Device	XC886/888CLM Series
Marking/Step	ES AB
Package	PG-TQFP-48/64

This Errata Sheet describes the deviations from the current user documentation. The module oriented classification and numbering system uses an ascending sequence over several derivatives, including already solved deviations. So gaps inside this enumeration can occur.

- XC886/888C-6/8FF
- XC886/888CM-6/8FF
- XC886/888CLM-6/8FF

Figure 1 Critical Cases for Power up/ Power down when $V_{residual} > 500mV$

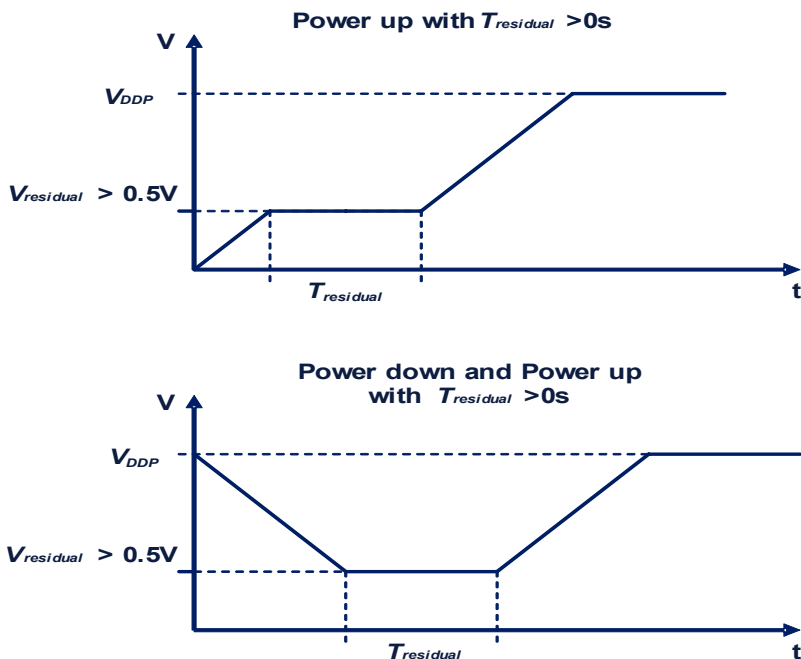
EVR_XC8.005 Reset toggling issue for repeated power up

Due to the limitation of the EVR, the reset toggling may occur during the power up. To prevent the reset toggling issue for power up, the following conditions must be met :

1. For power up, the rising time must be less than 2ms/V.
2. The power down time must be more than 0.2ms/V.
3. A permanent V_{DDP} residual voltage is less than 500mV.

In case of V_{DDP} residual voltage is more than 500mV, the holding time of residual voltage affects the reset toggling issue. **Figure 1** shows the critical cases for power up/power down when the residual voltages is held for some time. **Figure 2** shows the uncritical case for power up and power down when the power up is triggered immediately after power down. In case of a residual voltage due to immediate power up after power down, the users have to contact IFX to ensure no power up failure.

None.

Figure 3

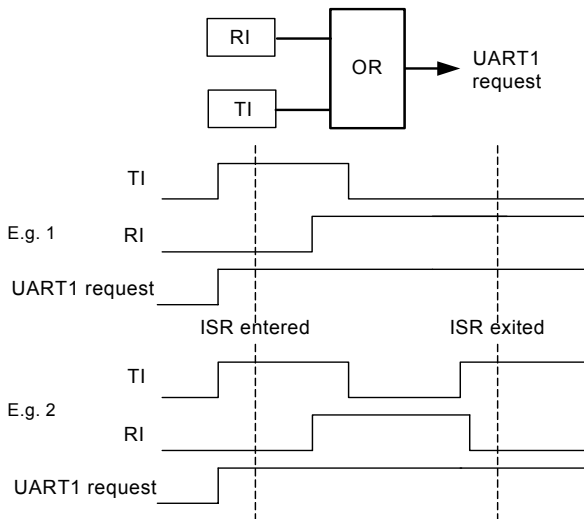
INT_XC8.004 Unable to Detect New Interrupt Request if Any One of Timer 2/UART1 Interrupt Flags Is Not Cleared (Unexpectedly)

As illustrated in the simplified figure, the UART1 interrupt flags RI and TI are combined as one interrupt request output. These flags are located within the UART1 kernel, with a single interrupt request line as output from the kernel.

Being of interrupt structure 2, the interrupt request of UART1 is detected on the rising edge of a positive pulse.

The problem is that it may occur at some point in the application, that any new UART1 interrupt request can no longer be detected after a return-from-interrupt (reti) due to service of earlier event(s). This happens when the following conditions are true:

1. UART1 events are serviced by interrupt (i.e. flags are checked and cleared only in the interrupt routine ISR),
2. Either RI or TI is set at any one time throughout the ISR (even while the other is cleared) such that at least one of the flags is still set after reti, causing the UART1 request line, which is an OR-function of the two flags RI and TI, to remain set throughout the ISR and after reti.

There are two suggested workaround:

1. If other events of interrupt node XINTR8 (EX2) need not be enabled for interrupt, disable this interrupt node and use software polling of the flags instead.
2. Before return from interrupt, check again if RI or TI is (still) set (due to new request since the last check). If so, jump and execute the ISR routine from start. Exit only when all flags are checked to be cleared. However, dummy

interrupt of the node may occur after return from interrupt, and should be ignored. Another drawback is if UART1 events are occurring at high rate, the CPU may be 'stuck' in the service routine of the UART1 interrupt for a long time.

Figure 6 FIFO structure

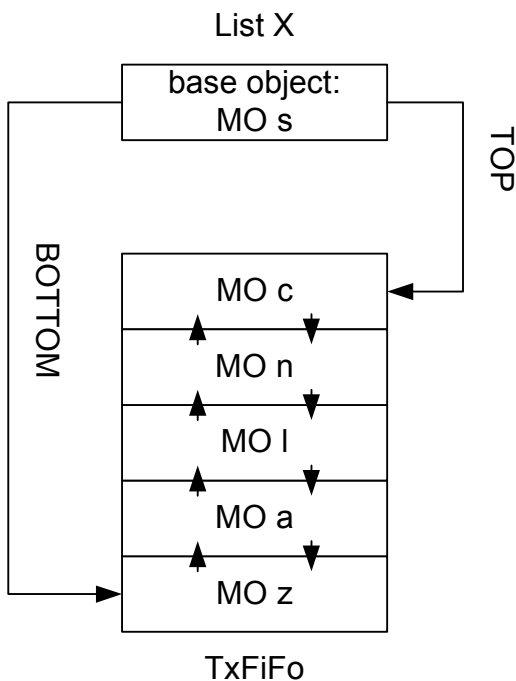
MultiCAN TC.029 Tx FIFO overflow interrupt not generated

After the successful transmission of a Tx FIFO element, a Tx overflow interrupt is generated if the FIFO base object fulfils these conditions:

- Bit `MOFCR.OVIE=1`, AND
- `MOFGPR.CUR` becomes equal to `MOFGPR.SEL`

A Tx FIFO overflow interrupt will not be generated after the transmission of the Tx FIFO base object.

If Tx FIFO overflow interrupt needed, take the FIFO base object out of the circular list of the Tx message objects. That is to say, just use the FIFO base object for FIFO control, but not to store a Tx message.

Figure 9

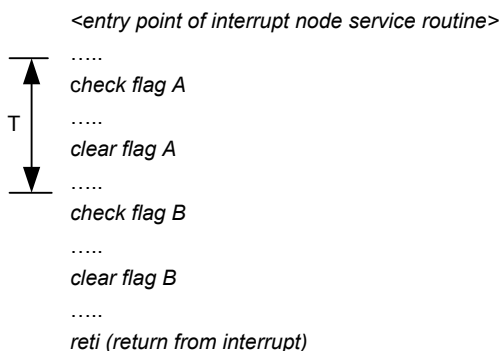
INT_XC8.H004 NMI Interrupt Request With No NMI Flag Set

It might occur in the application, that sometimes NMI interrupt requests are serviced, but no active NMI interrupt flags are found.

Consider the following NMI interrupt service routine pseudo-code, and scenario where a NMI interrupt source A event leads to interrupt request of the NMI node and CPU vectors to the NMI interrupt routine. Meanwhile, NMI interrupt source B and its flag becomes active any time in the duration indicated by T:

In this case, NMI flag B will be cleared as a standard procedure by the NMI interrupt routine in the current service. However, the pending interrupt request for the NMI node remains activated after RETI, as it is only cleared by hardware when CPU acknowledge the NMI interrupt and vectors to the NMI service routine.

This leads to following servicing of the NMI interrupt node again, but potentially no active NMI flag is found, i.e. dummy NMI interrupt service. The point to note is that the NMI interrupt source B is not lost, as it was actually serviced in the current service of the NMI interrupt node.

The recommendation is to ignore these dummy NMI interrupt vectoring.
